UNITED STATES PATENT AND TRADEMARK OFFICE

10/630,014

Office Action Summary

Response to Amendment

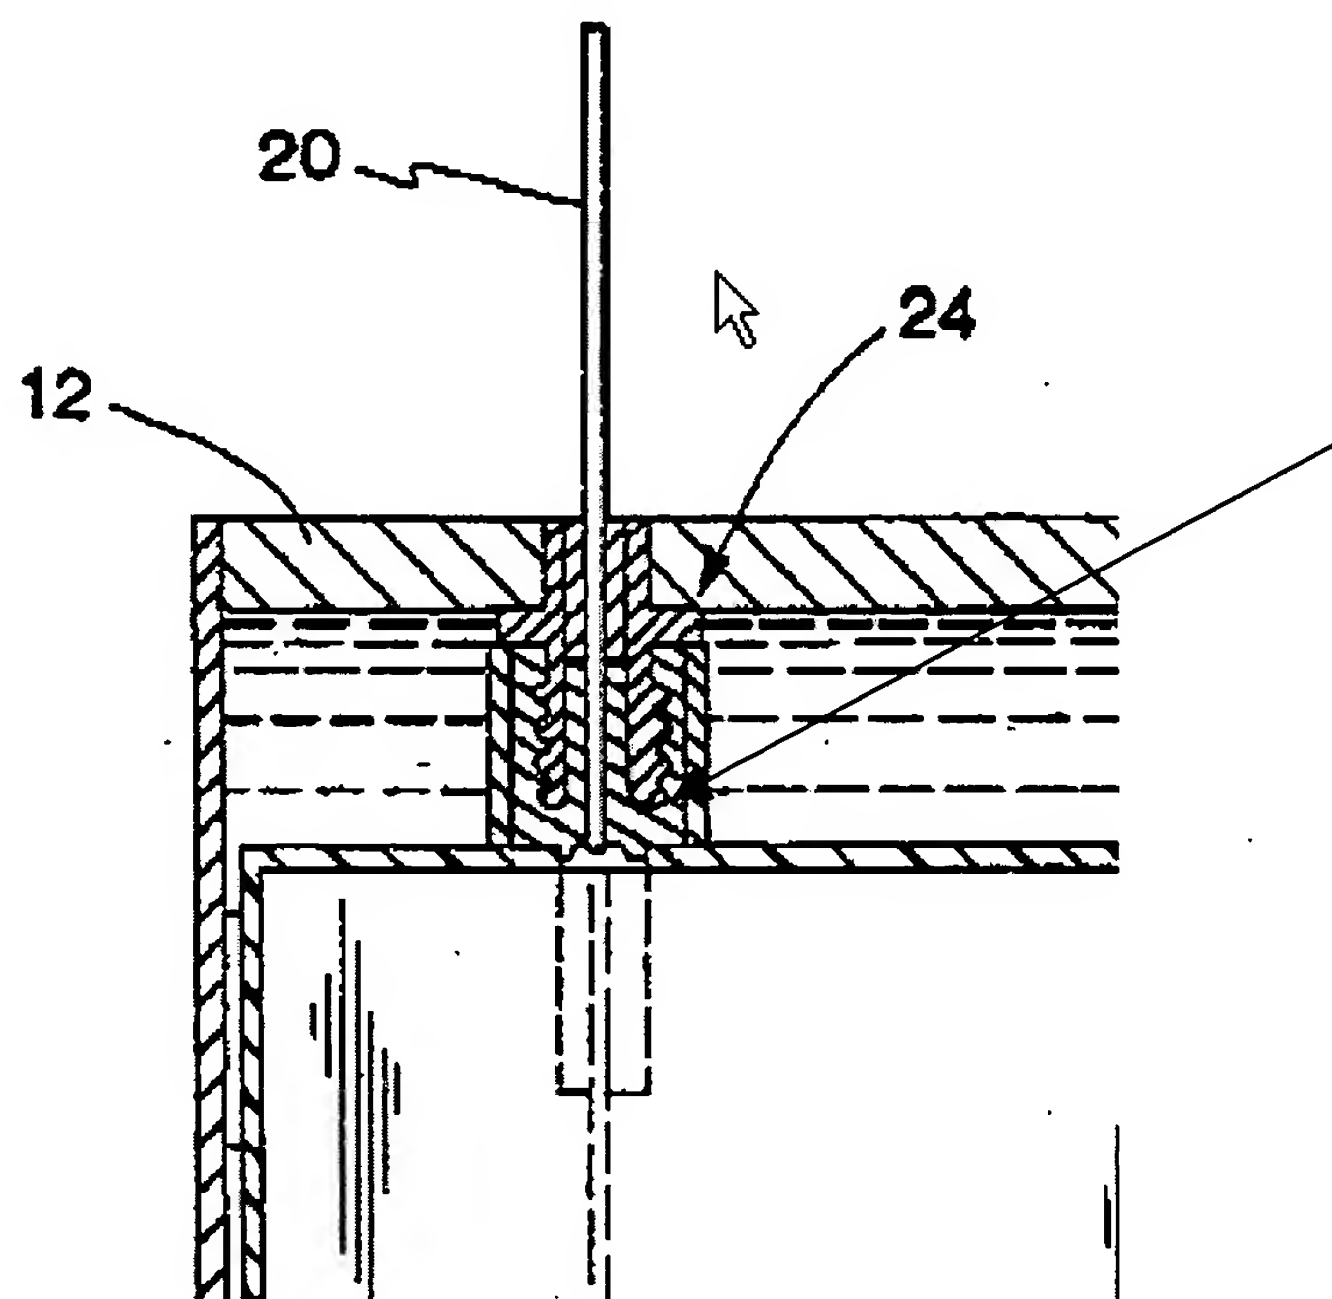
Heller does not disclose that the insulator encases the terminal lead from a lower surface of the sealing material to a location spaced below the lower ferrule surface (applicant's claims 1, 9, and 30). However, Cretzmeyer teaches an electrochemical cell

in which a material (see arrow) separates the current collector 20 from a terminal ferrule and encloses the terminal ferrule (fig. 1, reproduced below).

It would have been obvious to one of ordinary skill in the art at the time the invention was made to modify the insulation of Heller to completely enclose the terminal ferrule for the benefit of completely protecting the terminal ferrule.

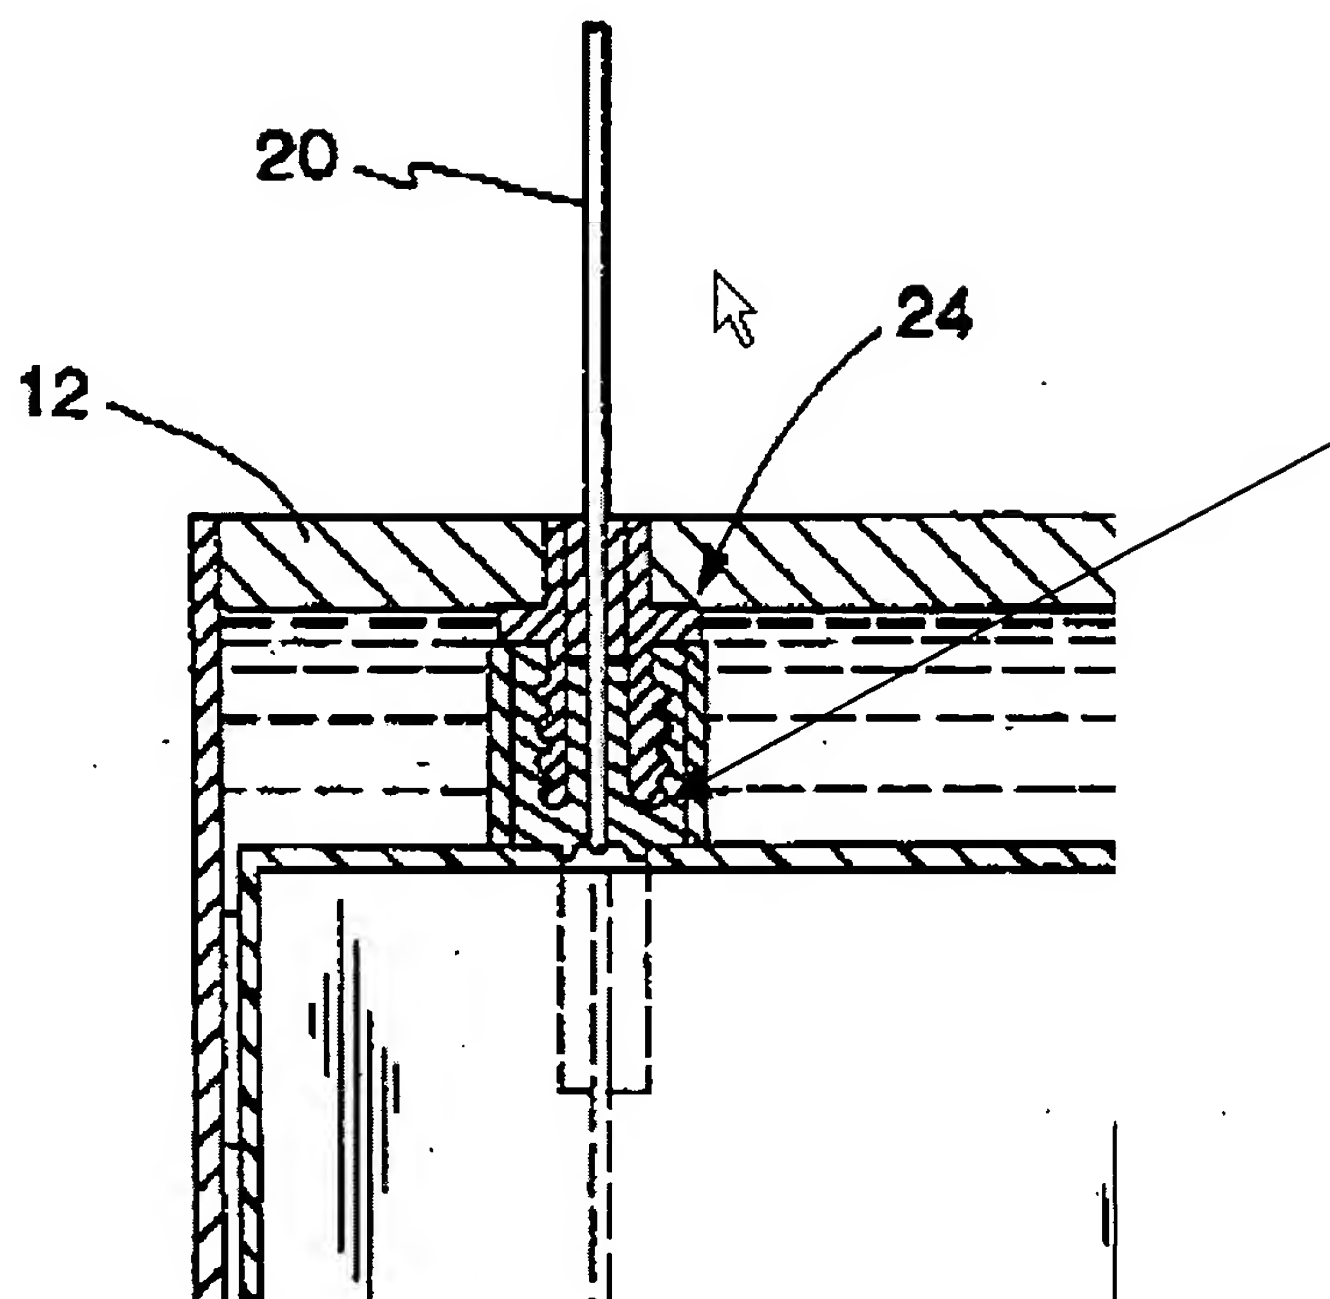
Heller does not disclose that the insulator encases the terminal lead from a lower surface of the sealing material to a location spaced below the lower ferrule surface (applicant's claims 1, 9, and 30). However, Cretzmeyer teaches an electrochemical cell in which a material (see arrow) separates the current collector 20 from a terminal ferrule and encloses the terminal ferrule (fig. 1, reproduced below).

It would have been obvious to one of ordinary skill in the art at the time the invention was made to modify the insulation of Heller to completely enclose the terminal ferrule for the benefit of completely protecting the terminal ferrule.
